ADDENDUM NO. 3

DATE: March 13, 2020

OWNER: Howard County Public School System

PROJECT: Hammond High School Renovation and Addition
Columbia, Maryland
Architect Project No. 18011

SHEET TITLE:
FIRST FLOOR PLAN - AREA B - LIGHTING

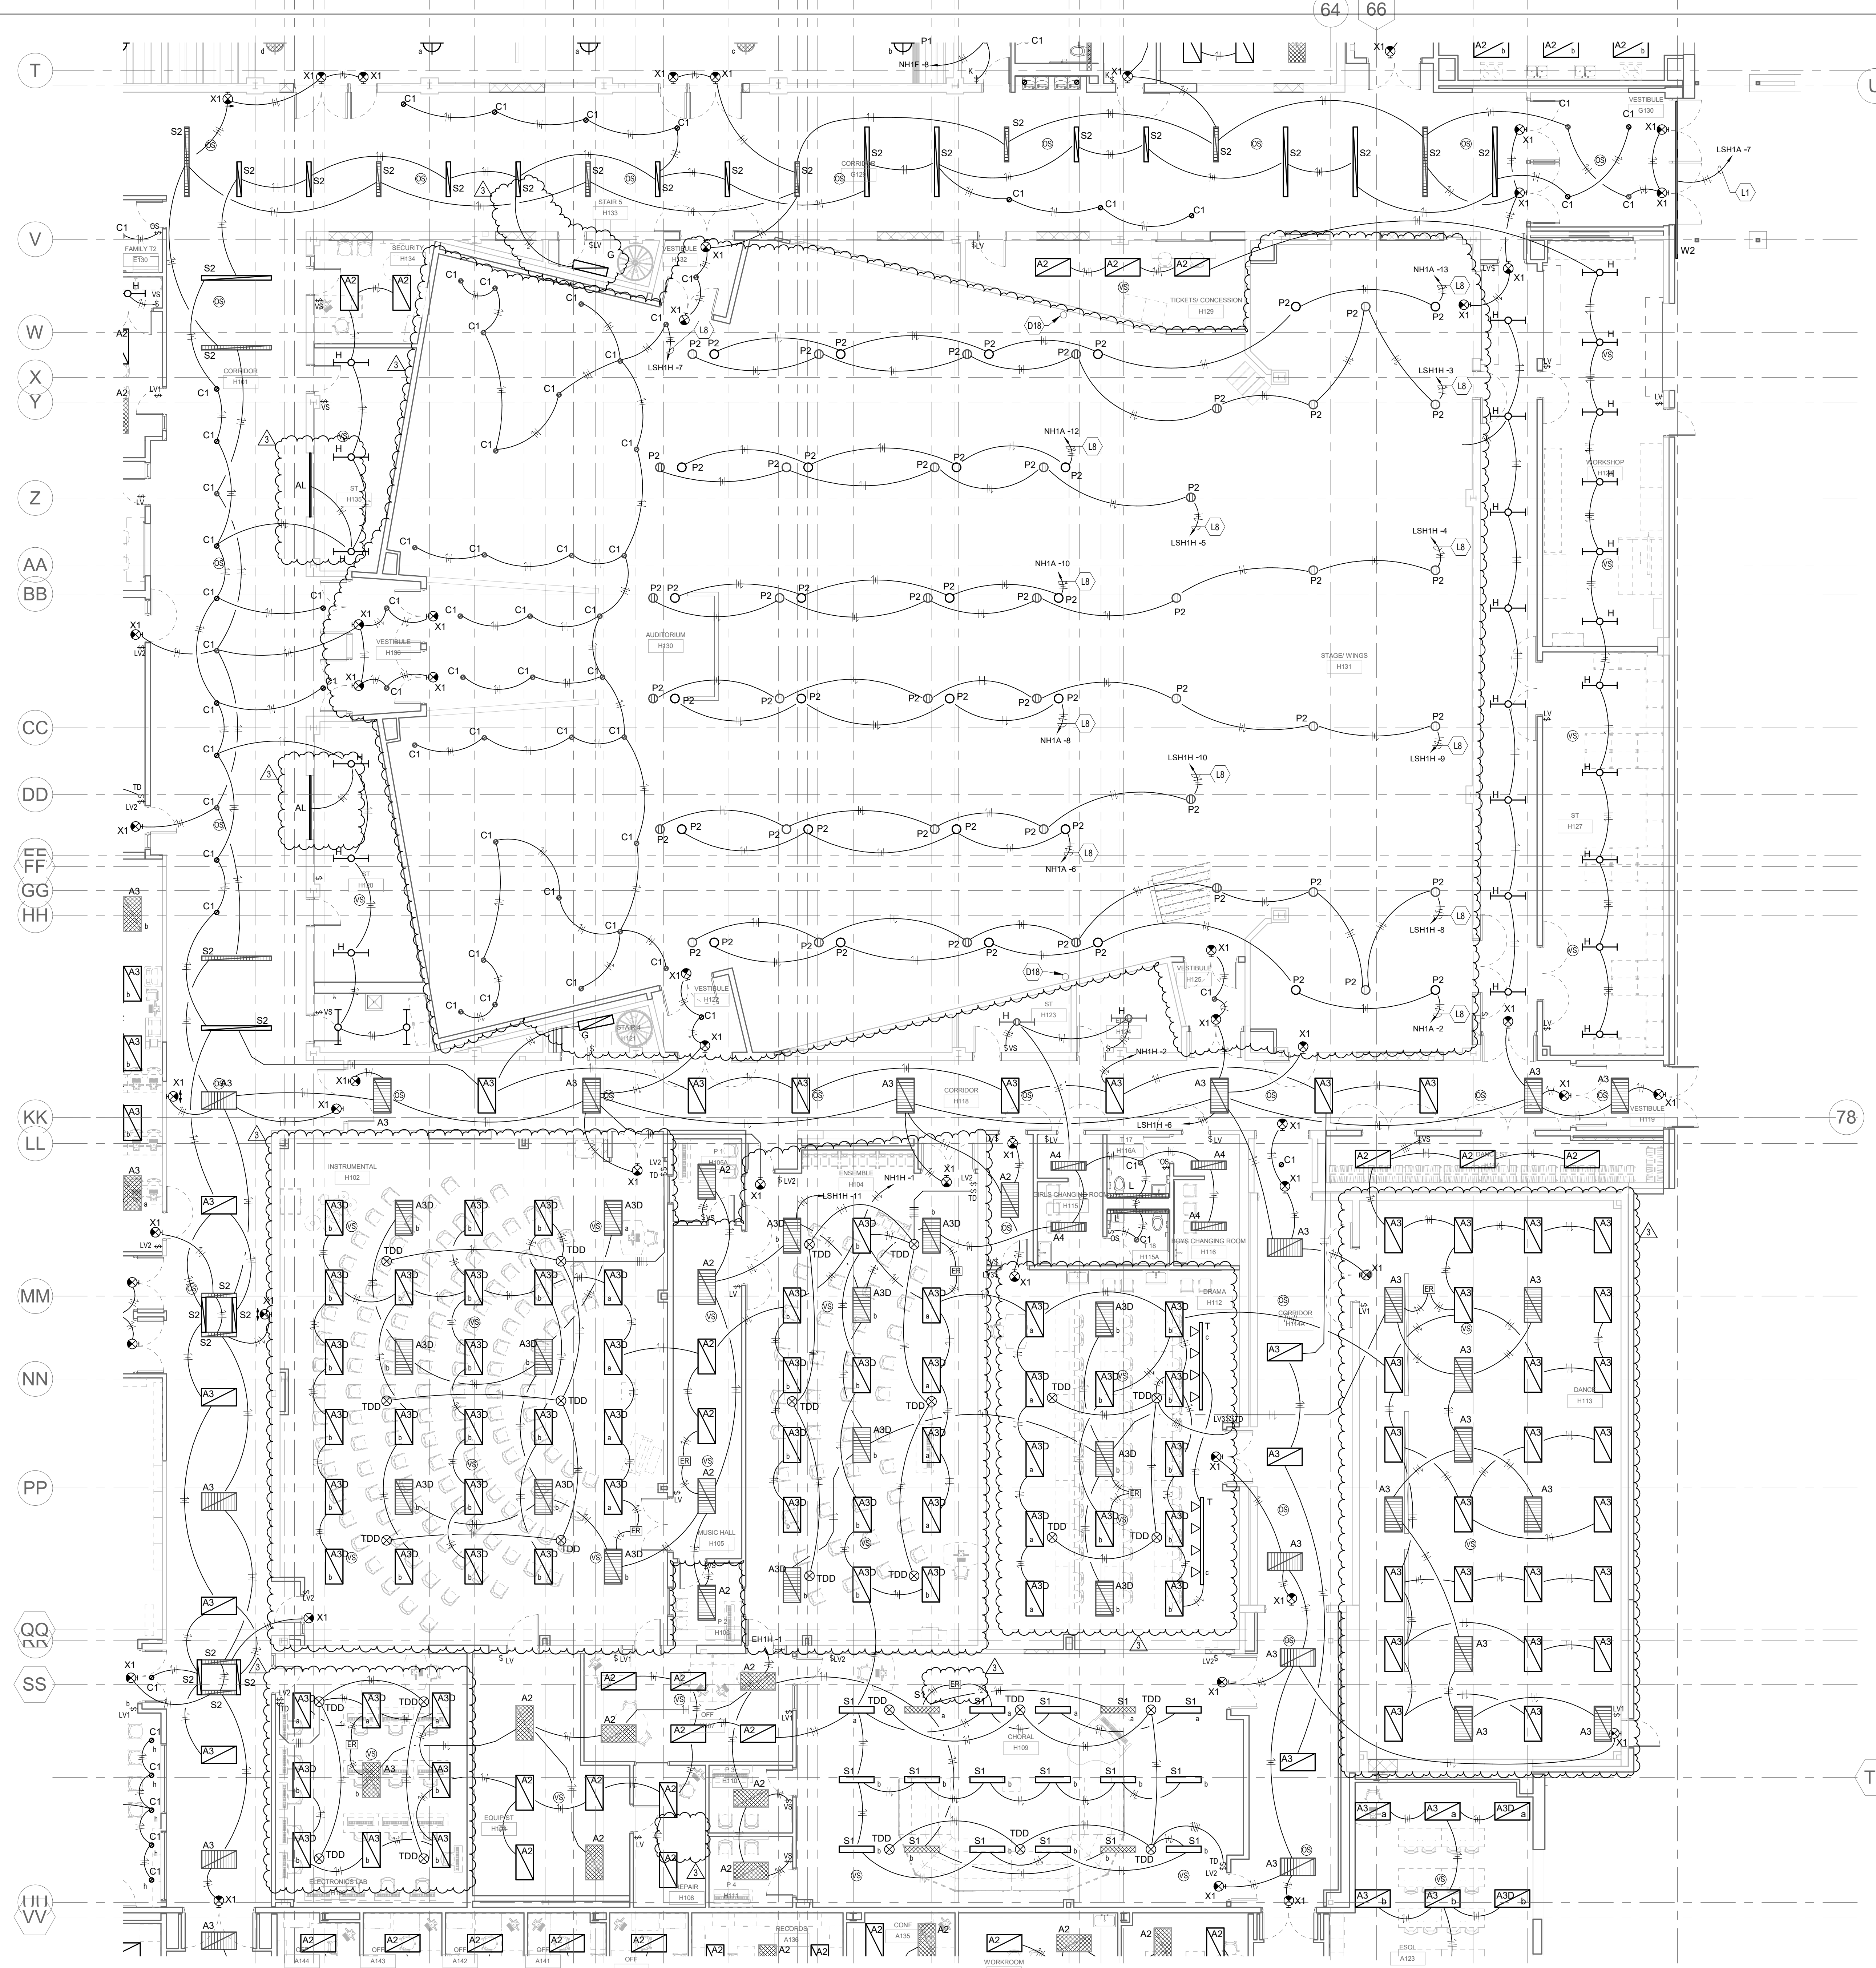
- Sheet E2.02 – First Floor Plan – Area B - Lighting
 - **REPLACE SHEET**
 - **REVISE** – All light fixtures in Innovation Lab B128 shall have integral daylight sensors. Refer to Elec – Luminaire Schedule for additional information. Coordinate exact requirements with manufacturer prior to construction.

- **REVISE** – Light fixtures and controls added to TV Studio B129. Refer to revision clouds for additional information.
- Sheet E2.03 – First Floor Plan – Area C - Lighting
